Tinsmith Corner

Road Safety Audit

March 2017

Figure 8 - Tinsmith Road approach- Cross road sign obscured by vegetation from further back.

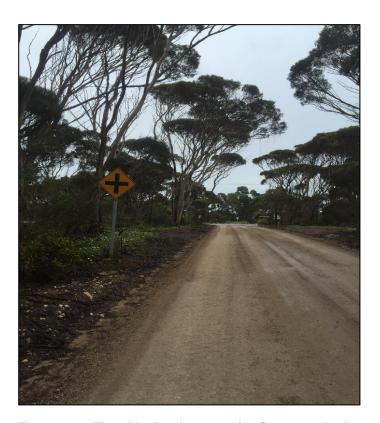
- a) Advanced warning and give way signs are obstructed by vegetation on approach to the intersection. This increases the risk that motorists do not become aware of the intersection and may fail to give way, increasing the likelihood of a crash. It is recommended that vegetation trimming or removal is undertaken in accordance with both DPTI and Kangaroo Island Council vegetation management plans to make the signs conspicuous.
